BID ADDENDUM NO. 3

CONSTRUCTION NEW GEORGE WYTHE HIGH SCHOOL (RHSA)

**IFB # 23 – 7061 – 11
RRMM Project # 21310 – 00**

**January 4, 2024
Architect of Record:
RRMM, Architects, PC
1317 Executive Boulevard
Suite 200
Chesapeake, VA 23320
Phone: 757-213-6350**

RICHMOND PUBLIC SCHOOLS
GEORGE WYTHE HIGH SCHOOL
 ELECTRICAL SITE PLAN

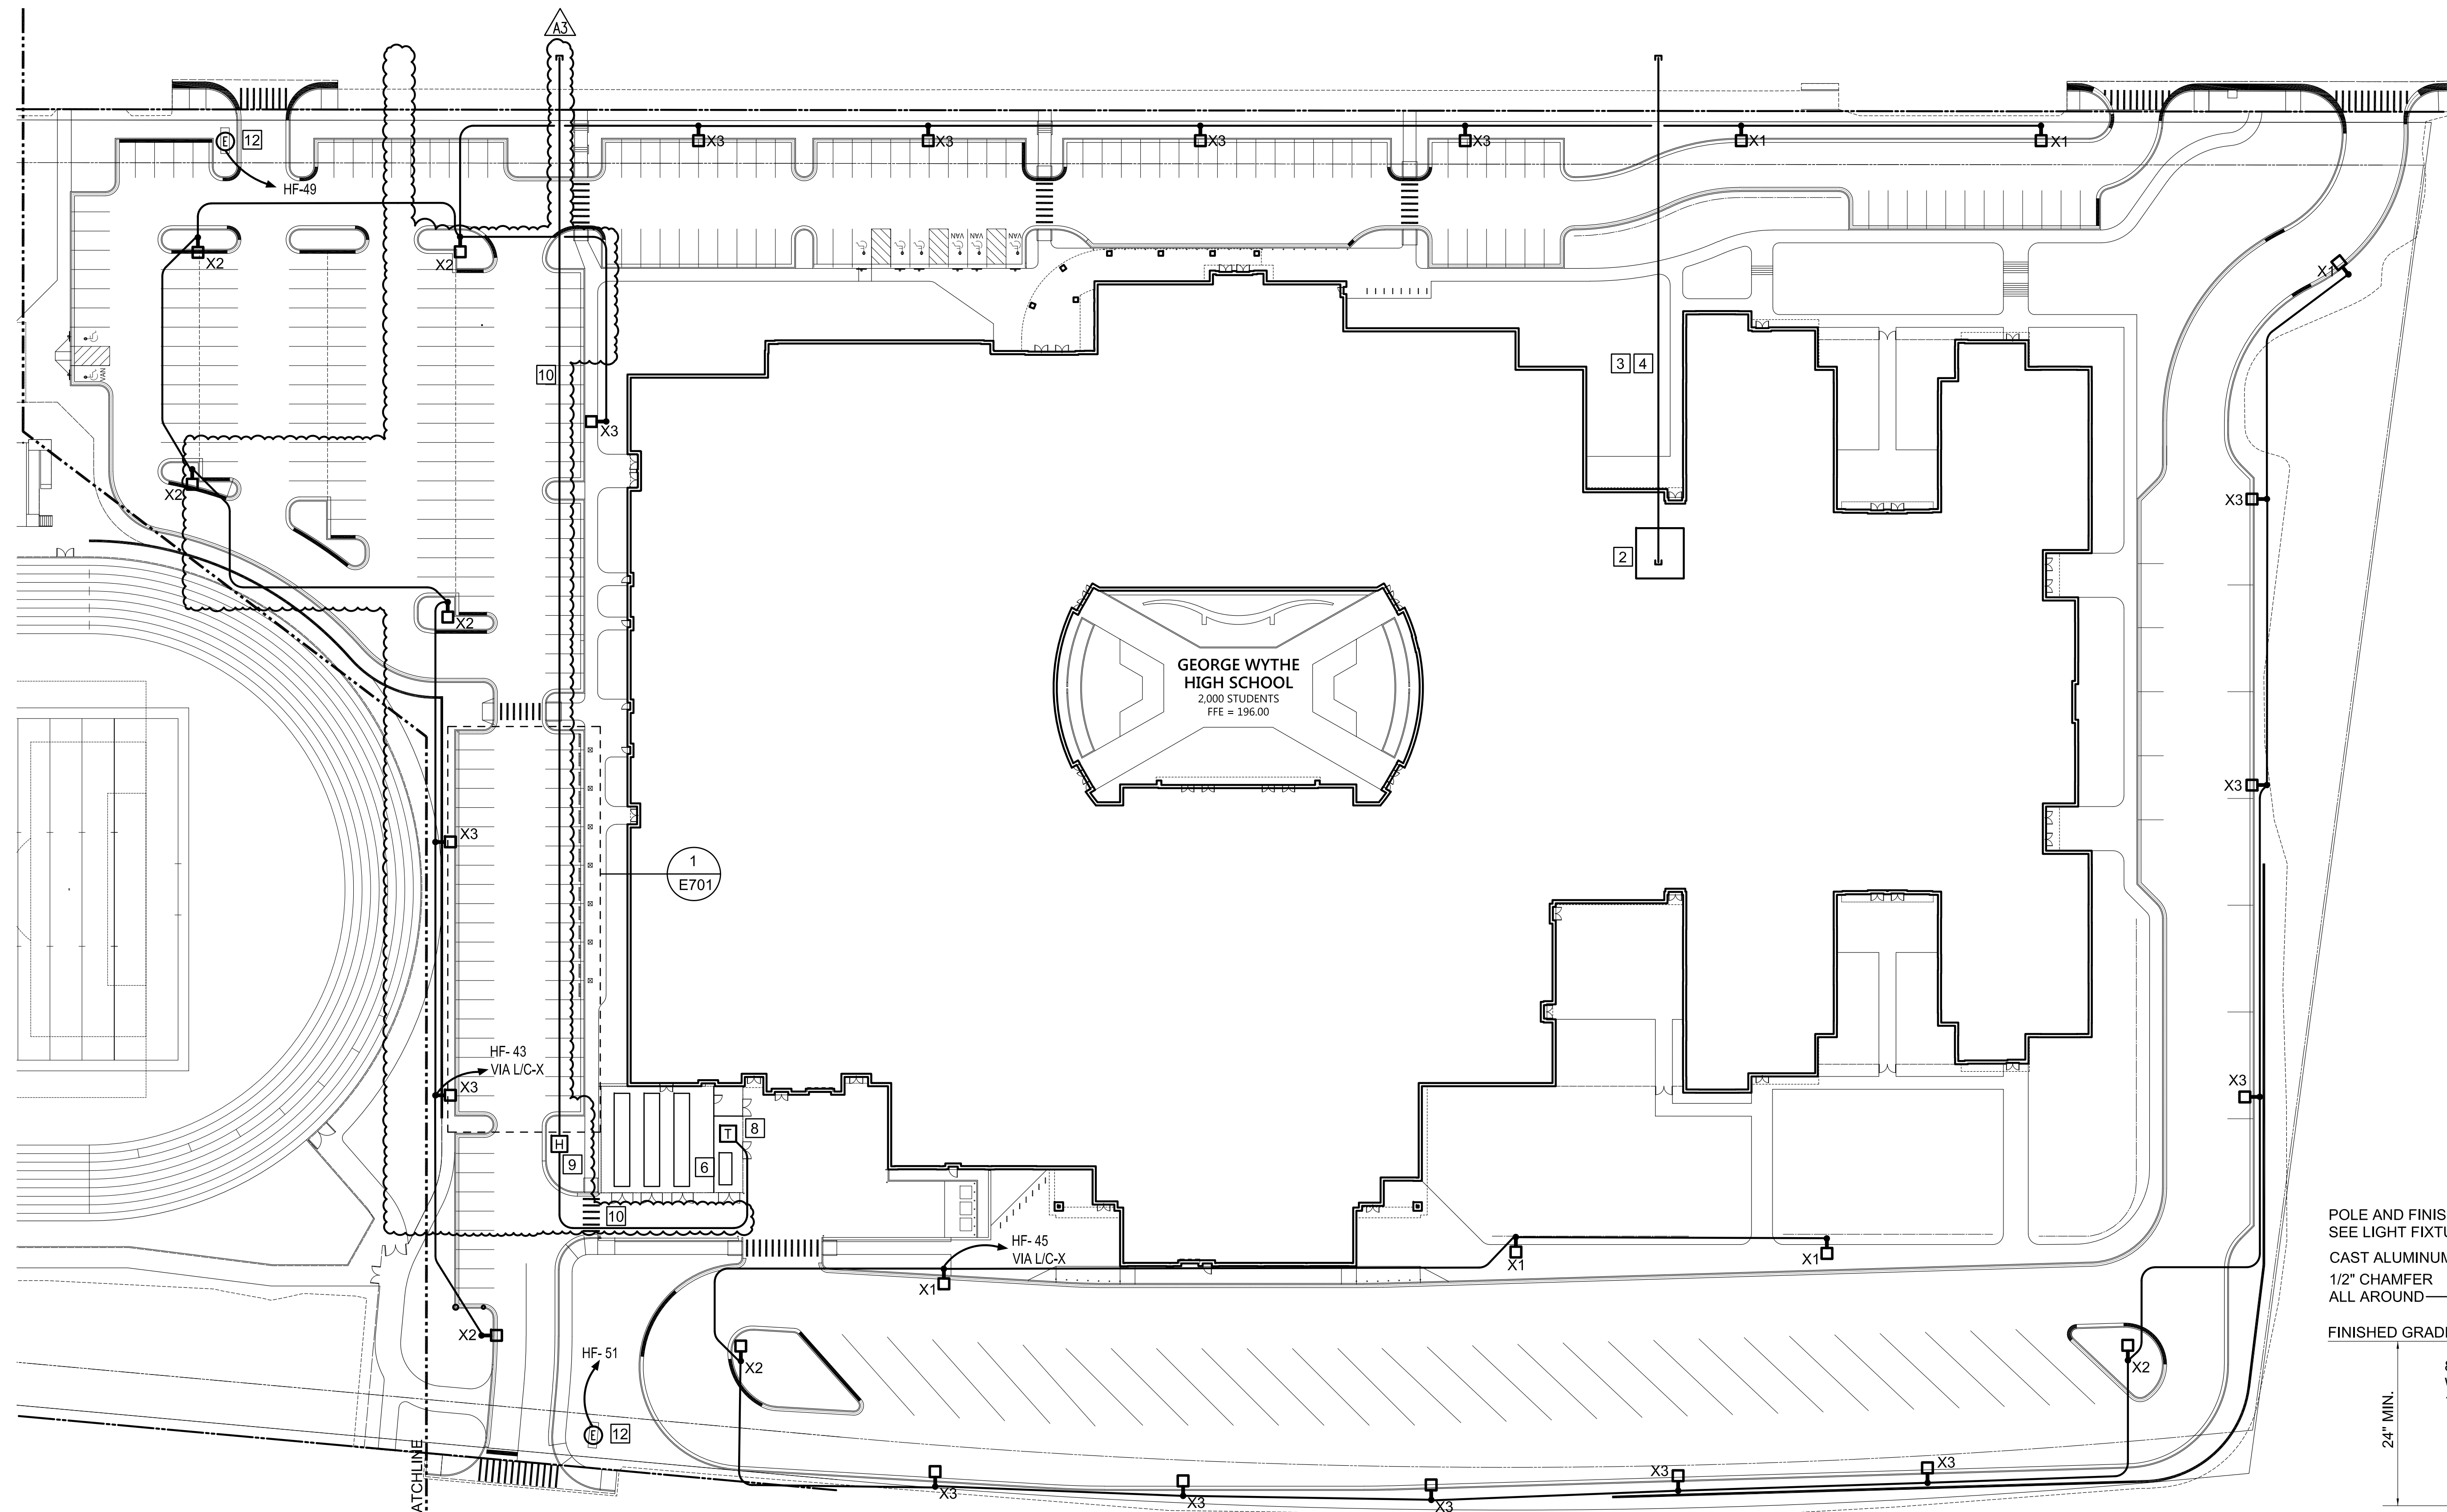
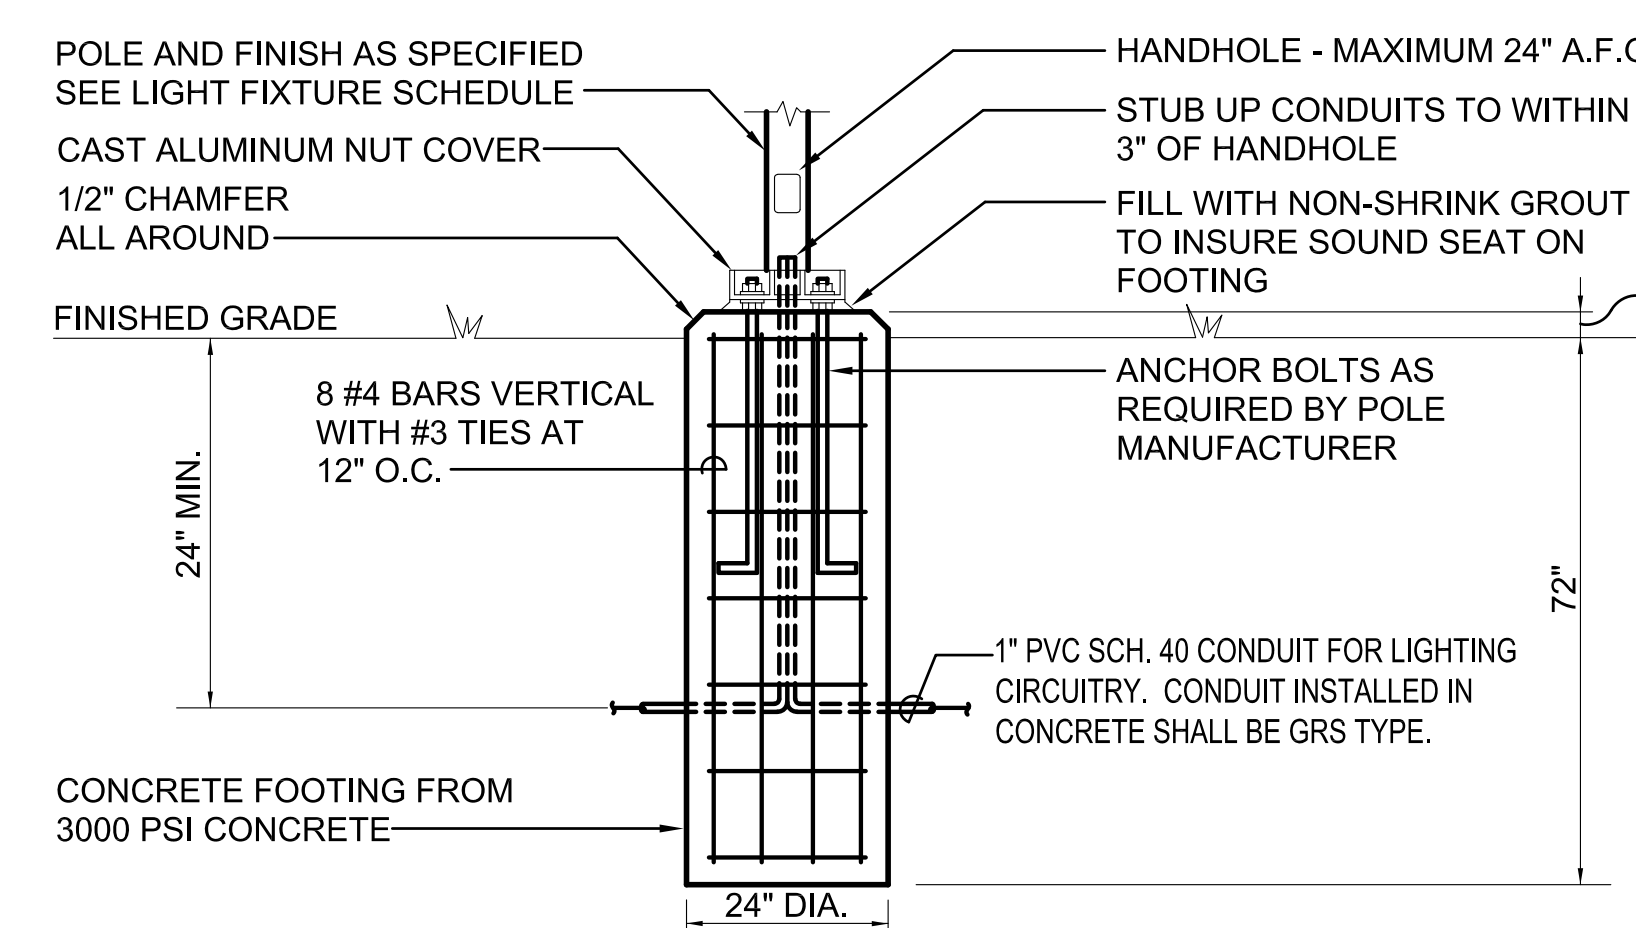
3.26 SHEET E-701 – ELECTRICAL SITE PLAN: REVISE conduit and handhole routing per the attached revised sheet.
